TECHNICAL BULLETIN

VANTRAAX® HKANT 40K

SUBJECT: Air Spring Change

LIT NO: L1003

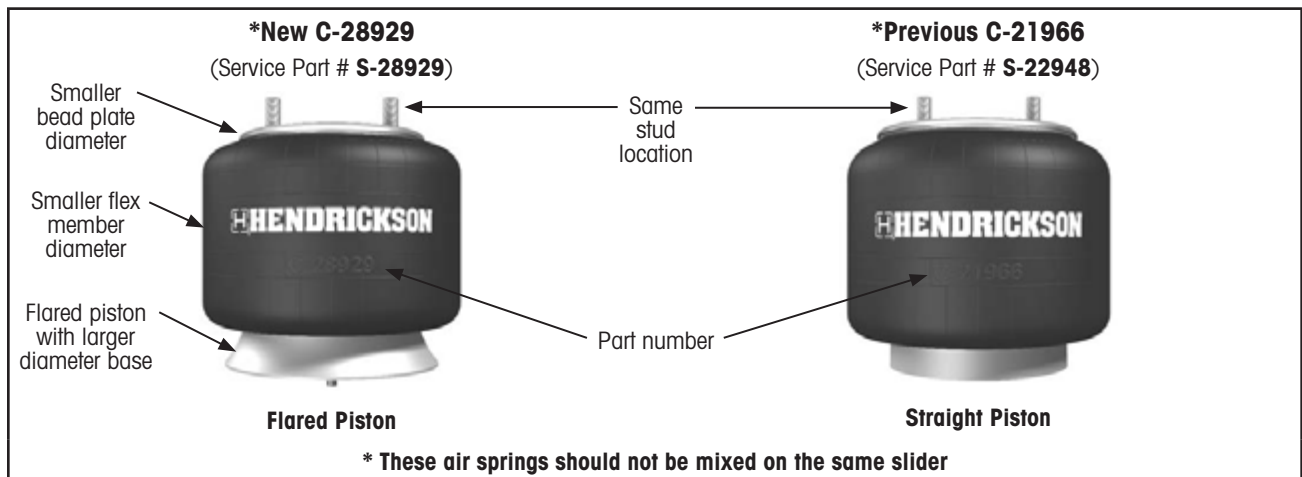
Hendrickson Trailer Suspension Systems completed an upgrade to a new air spring on production VANTRAAX® HKANT 40K sliders. As a reminder, the replacement part number does vary from the replacement air spring number on sliders previously produced.

The graphic below illustrates visual differences between the new air spring, C-28929 and our previous air spring.

Although both the previous and new air spring designs will fit the suspension beam identically, they operate at different pressures. Therefore, to maintain proper performance and avoid premature wear, they should not be mixed on the same slider. Refer to the chart below to determine what air spring to use when replacing your VANTRAAX HKANT 40K air springs.
